Bernheim - Change Order 21 - Site Storm Modifications **DC**

# **Change Order Request 27 - PCO #79 - Storm Exploration and Tie-in**

# Change Order Request 30 - PCO #85 - RFP-21 Cast Iron Hub Add; Deduct for Detention Basin Rev

### REQUEST FOR PROPOSAL

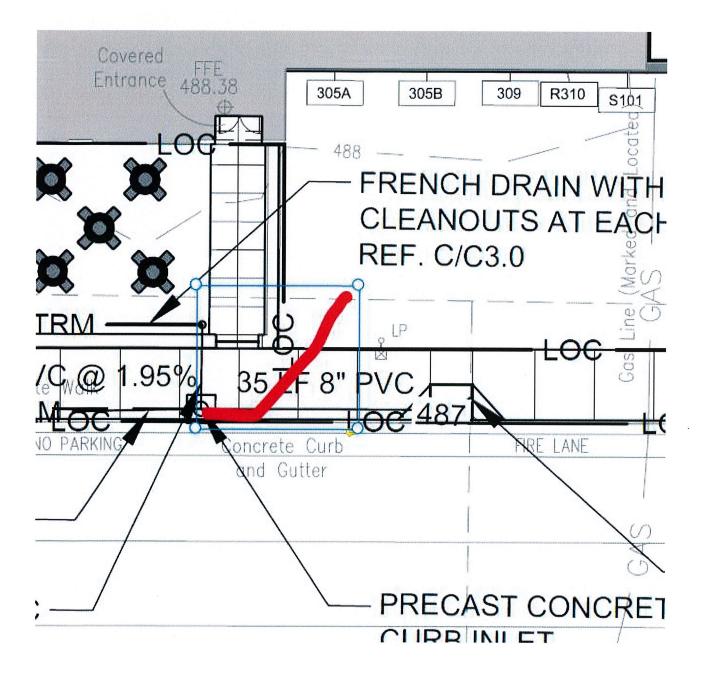
Hey guys- please take a look at the attached configuration to connect to the pipe you found. Do you think this solution to connect to the existing 18" would work? It looks from the pictures like we would have enough depth to make a set-over storm riser fit.

Yes, this is similar to what we were thinking.... I can get with my vendor on lead time for this product and follow up. We would like to proceed with the tie in to keep our schedule with our curb sub.

Below is what we are thinking this rout would allow us to keep our contract footage, we would only be out the field investigation, a few fittings, and the ADS Riser Tee. Let me know your thoughts if this something you guys would like us to proceed with. If so, I will get Grant a C.O. for the added materials and time for approval.

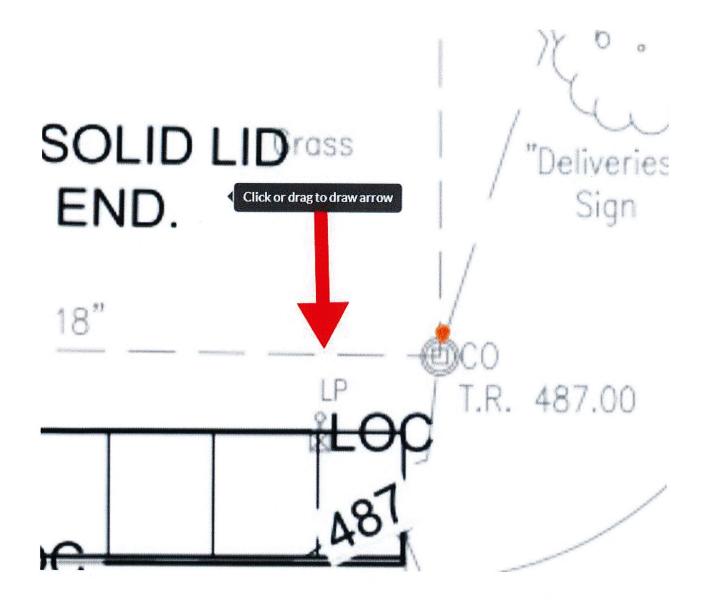
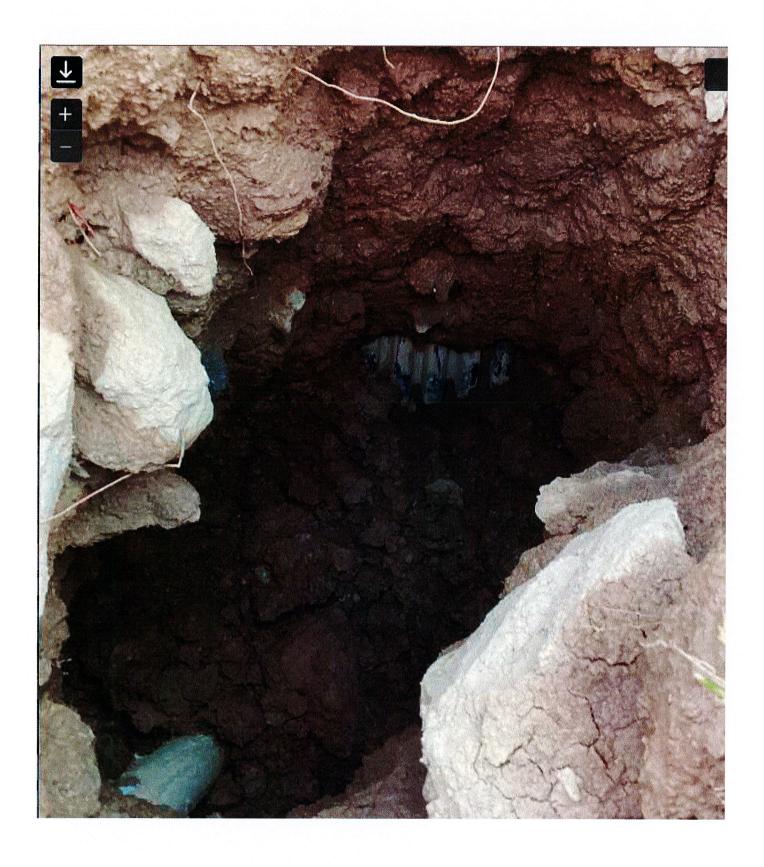
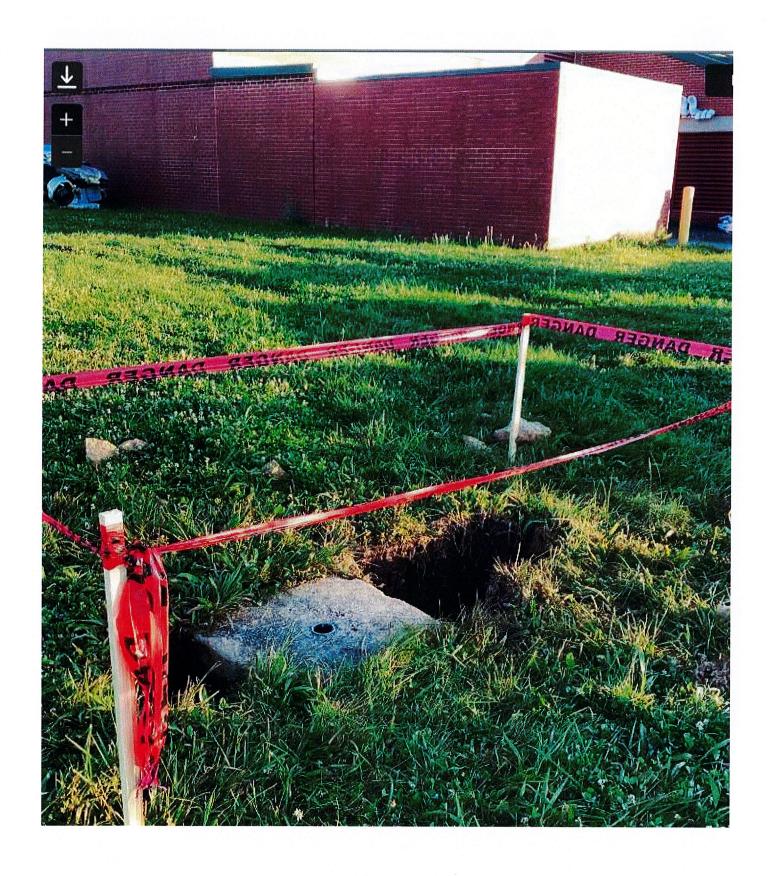
In good faith efforts Trademark vacuumed the area below and found the storm line, in general we have fall and the line is either a 12" or 18" storm line. We did not find the tee as its show on the drawings, but the trunk line is there. To keep the schedule I've instructed our men to proceed with the original storm design, as it does have ample fall between the existing and new line, I would like to meet someone on site to discuss the changes required to connect the storm line that was found to the new pipe we are installing. Thanks

I spoke with Stephanie at Studio Kremer – we are good with this approach. We'll need an official RFI from Calhoun for formal approval.

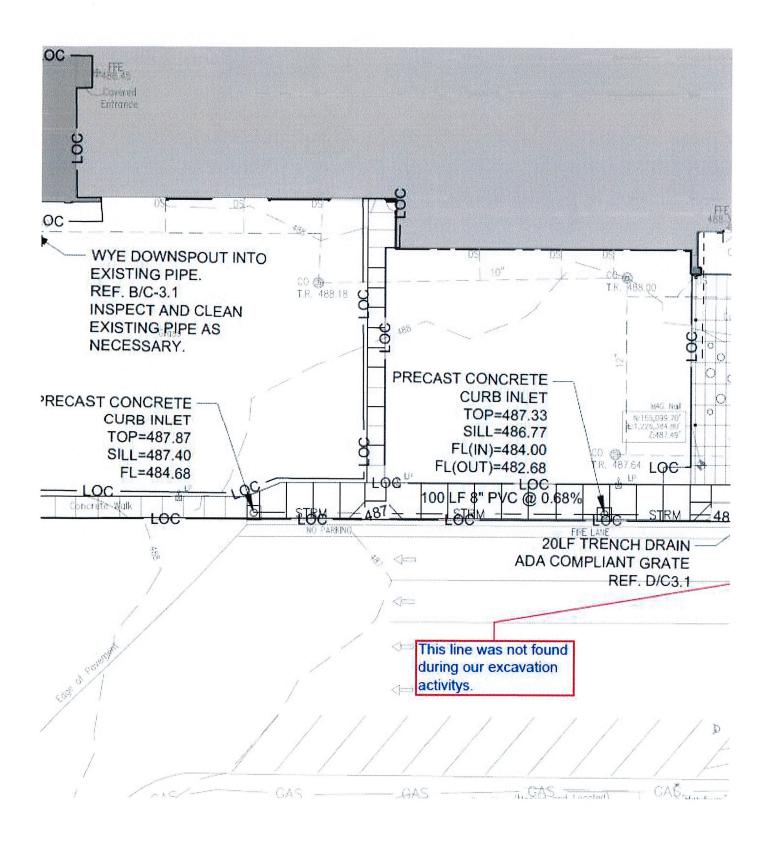
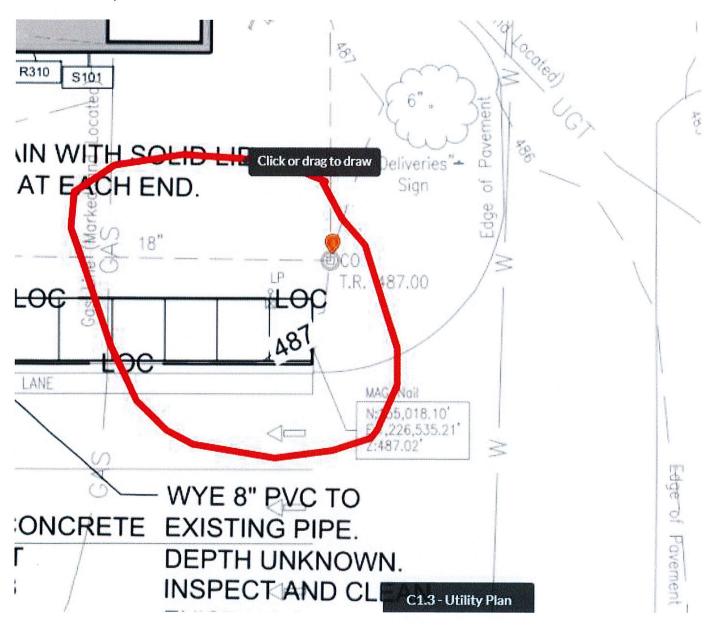
Thanks for taking my call, see below snapshot. The clean out shown has only a 2" opening and we can not confirm the elevation of this line nor the size of the box..... I've got some site pictures below to help you understand the issue... We need to excavate the clean out area up and see what's below to tie into. I would like permission to use a vacuum truck along with my storm crew for a day to do exploration on the storm so we can come up with a solution. I don't mind doing this T and M if that helps. See below and advise when you get a few mins.

Paul, we need to dig in the red circle below and above on Tuesday... If we can get approval, I will back feed this information asap!
